Replace Air Cooled Chiller  
Blatt PE Center  
University of South Carolina  
TP20000029

### Addendum One

June 24, 2020

SHEET: M1 OF SHEET IN SET: OF

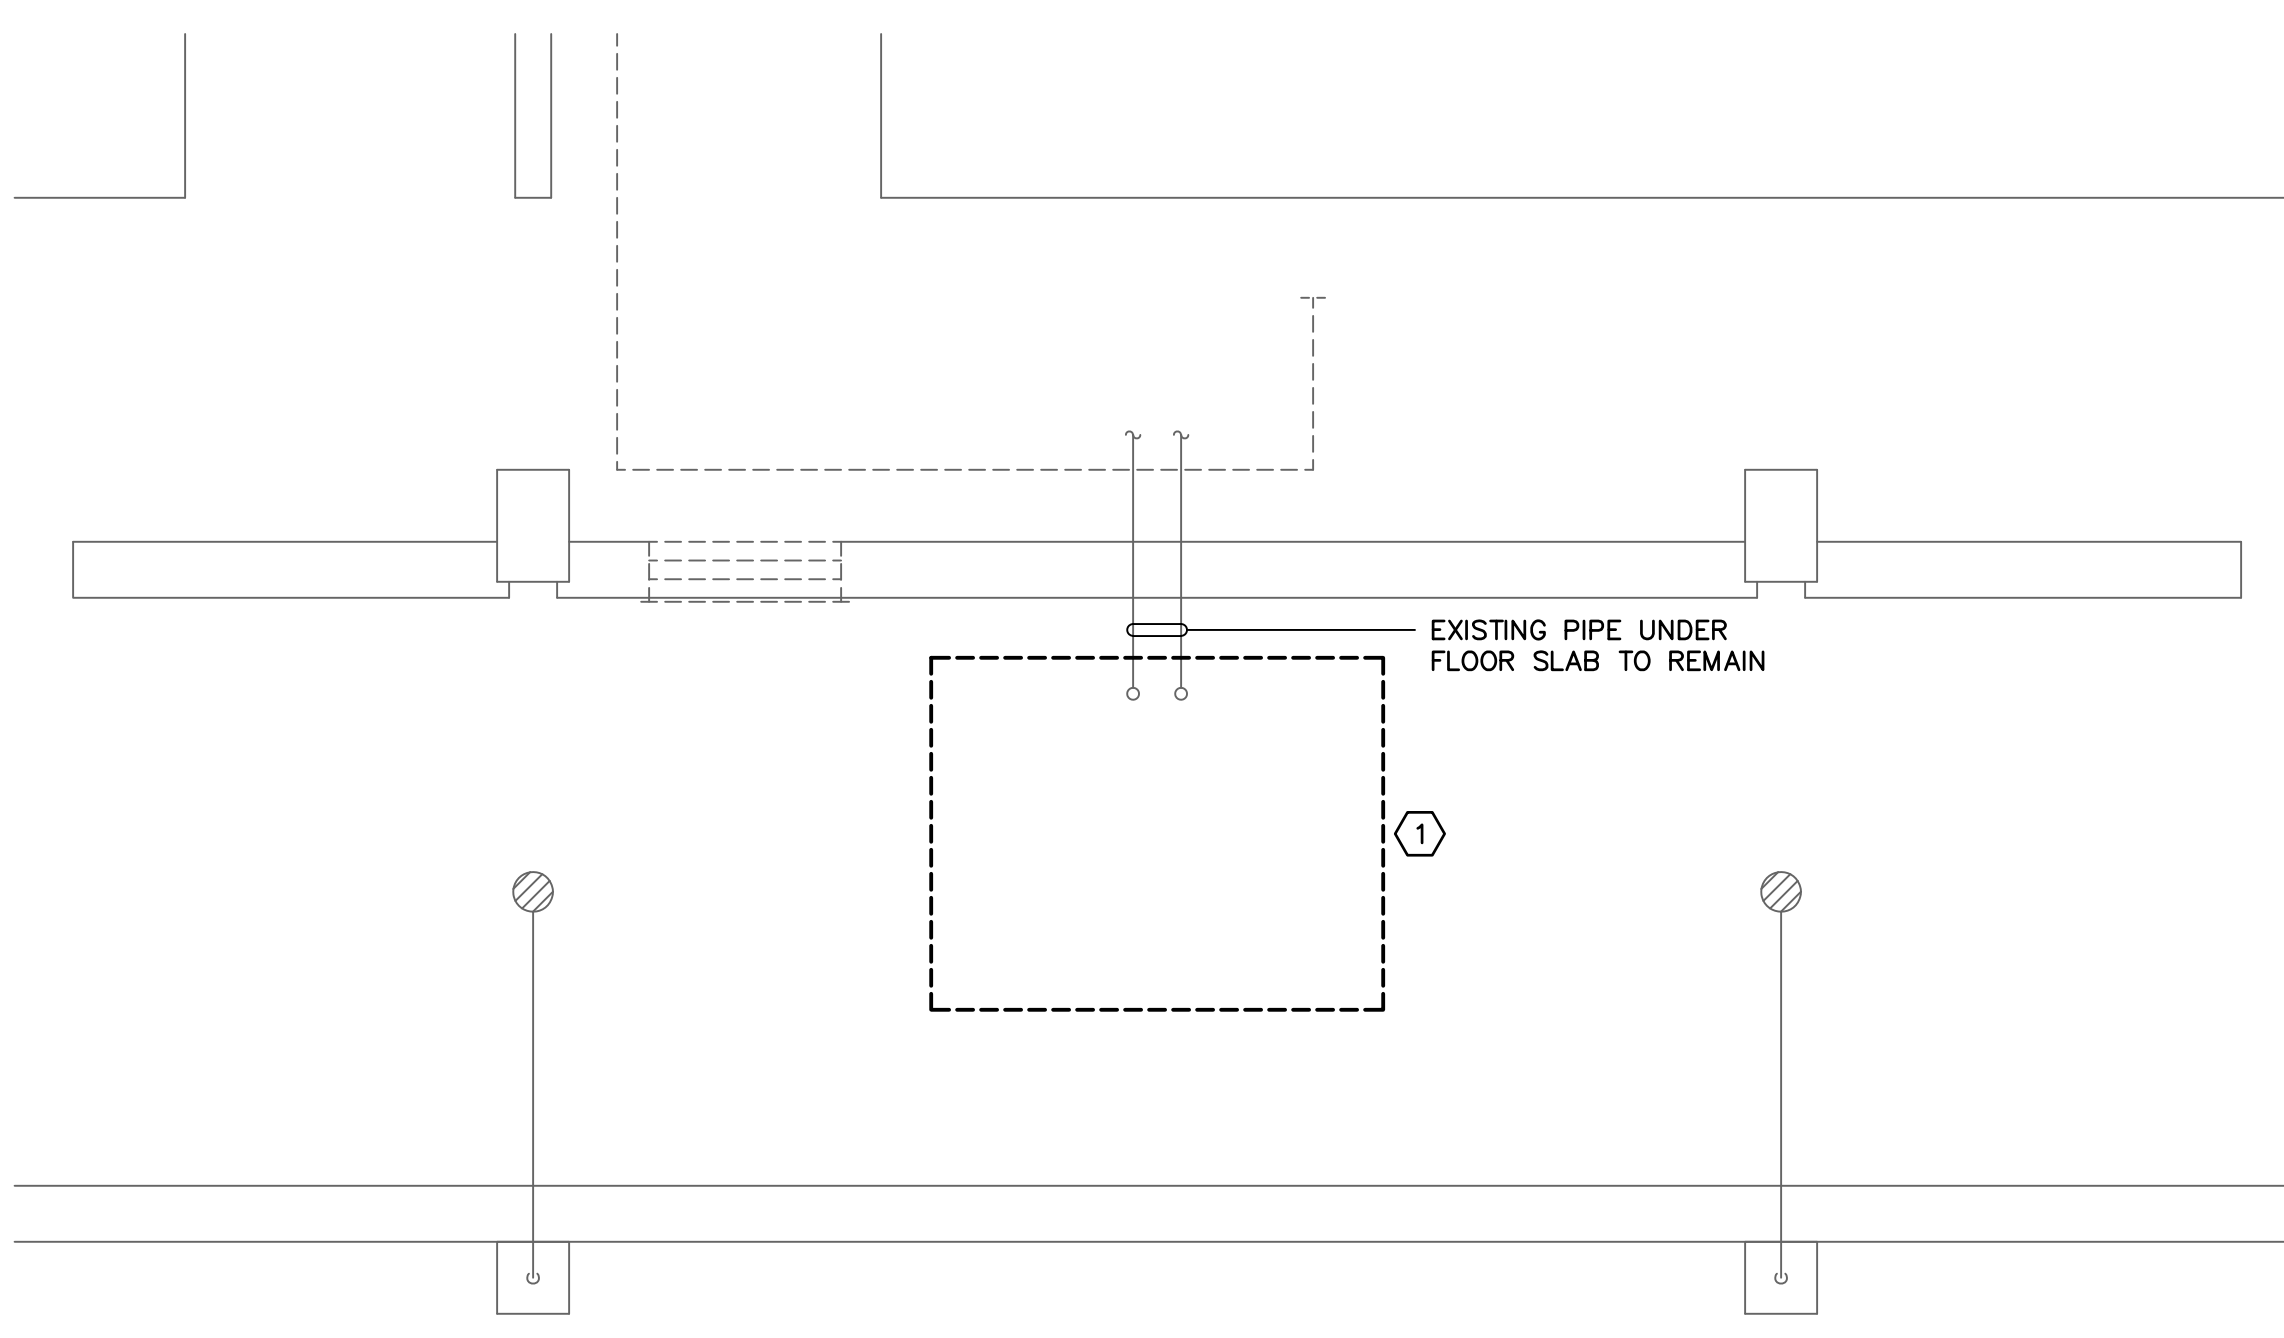
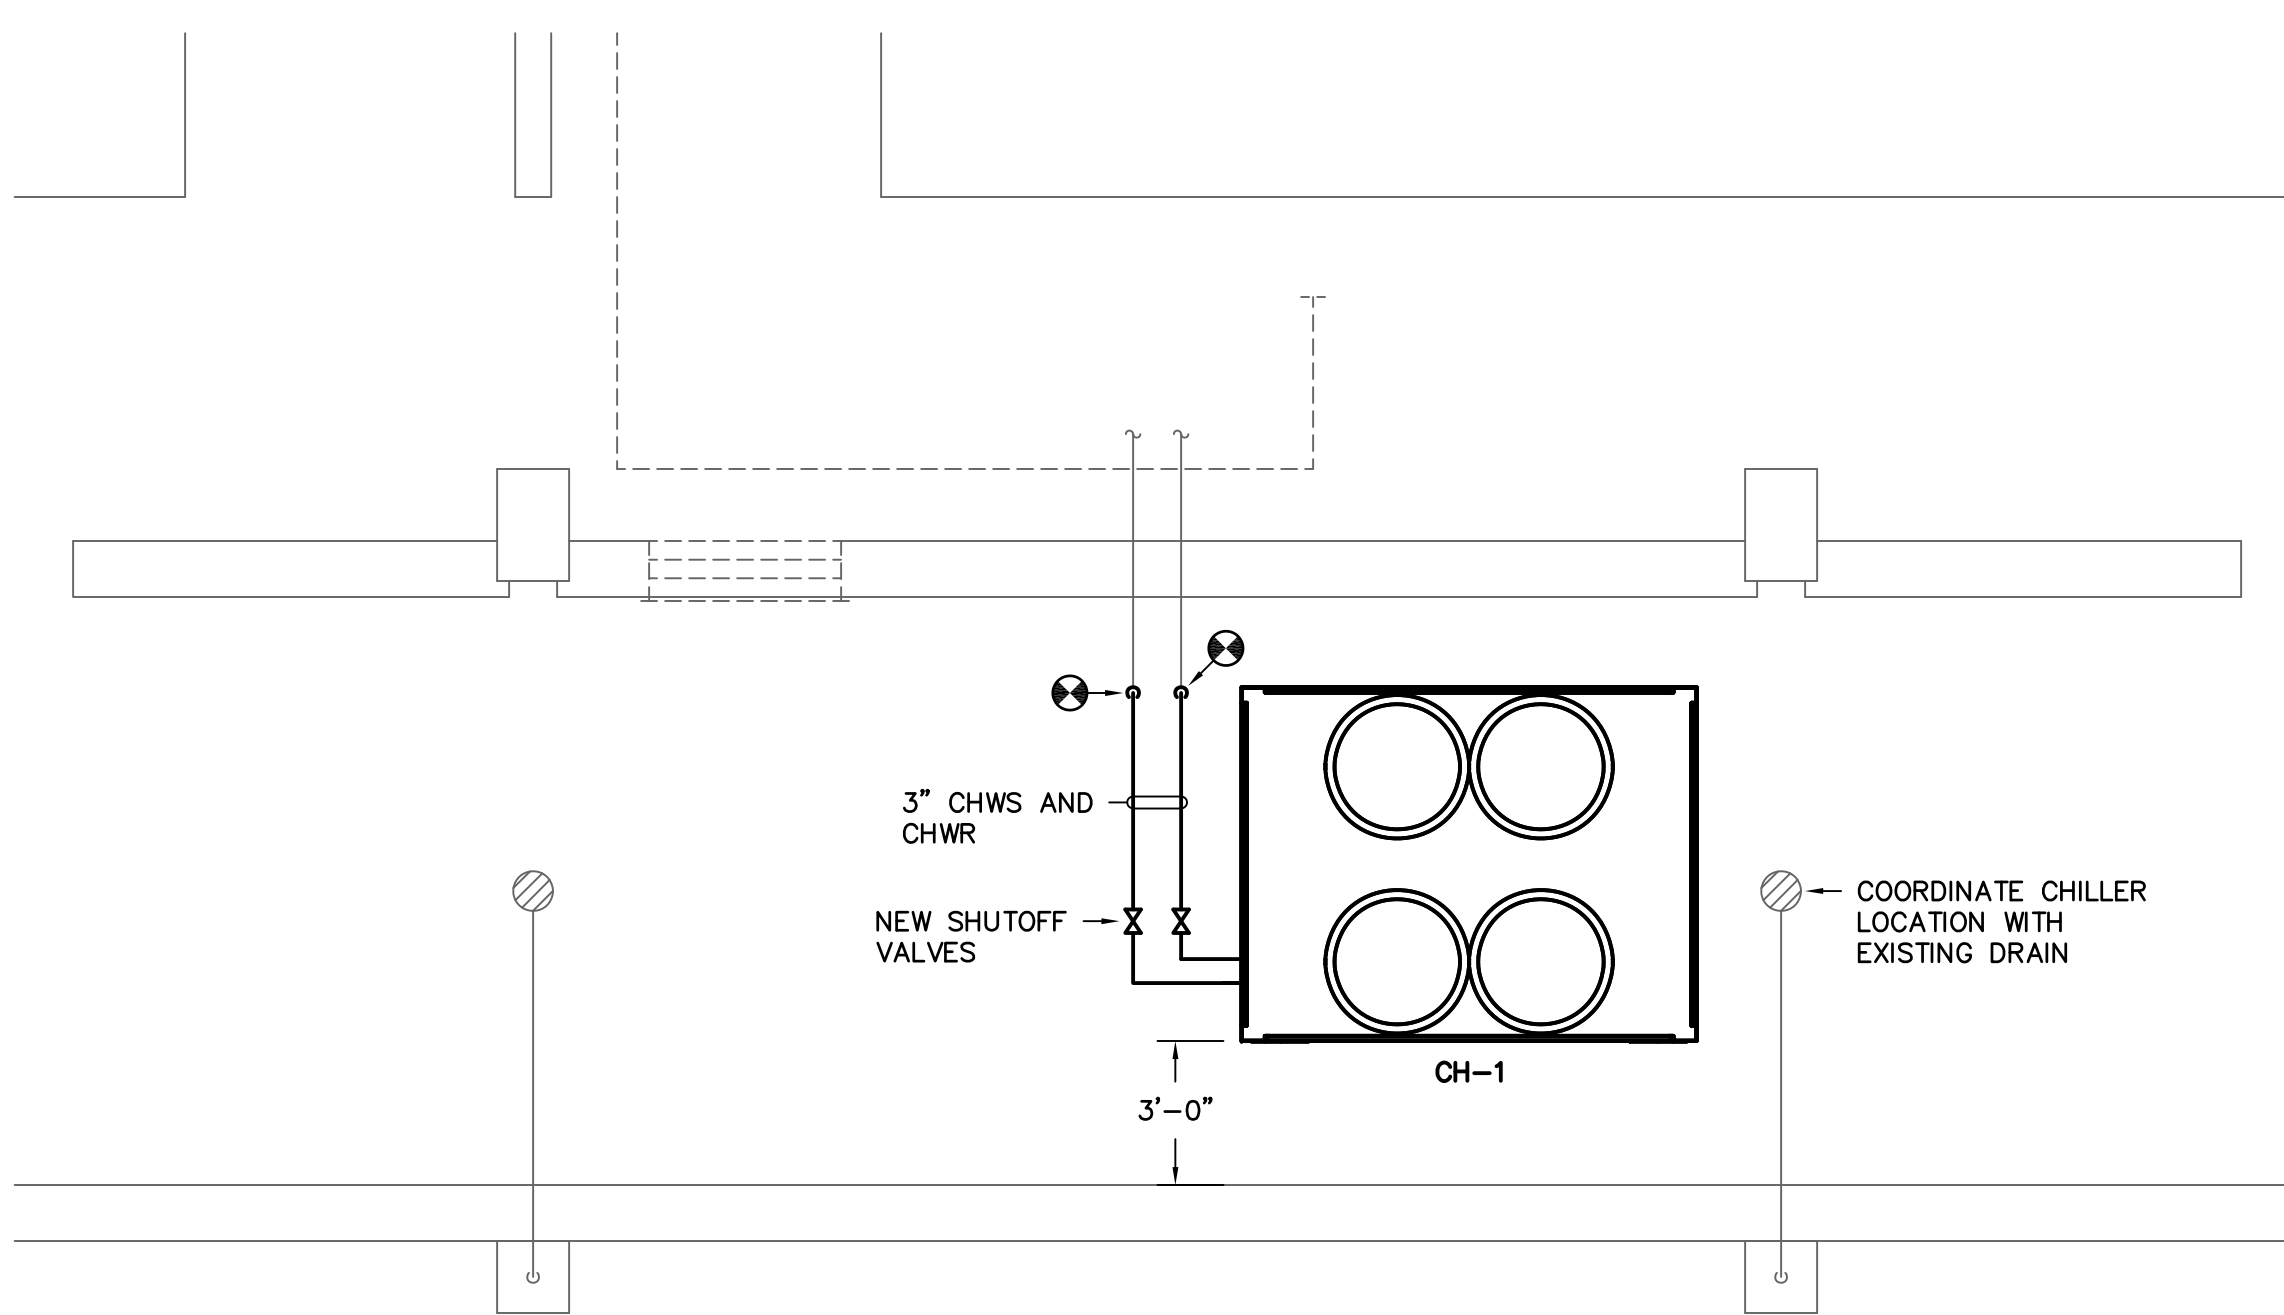
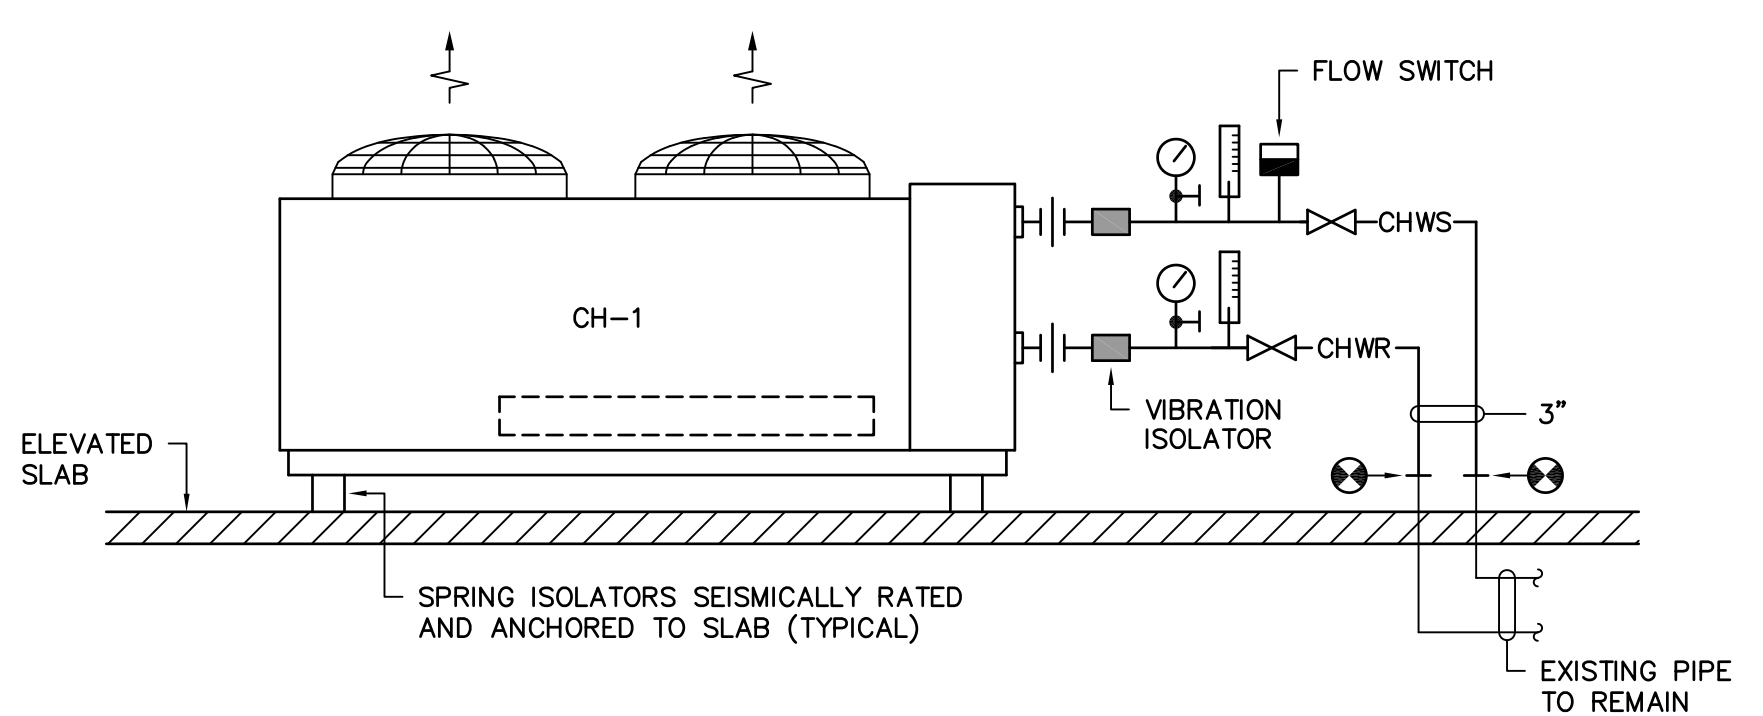
| 1.              | <u>Revision:</u> Reference Drawing M1. Chiller flow rate shall be 86 gpm. |
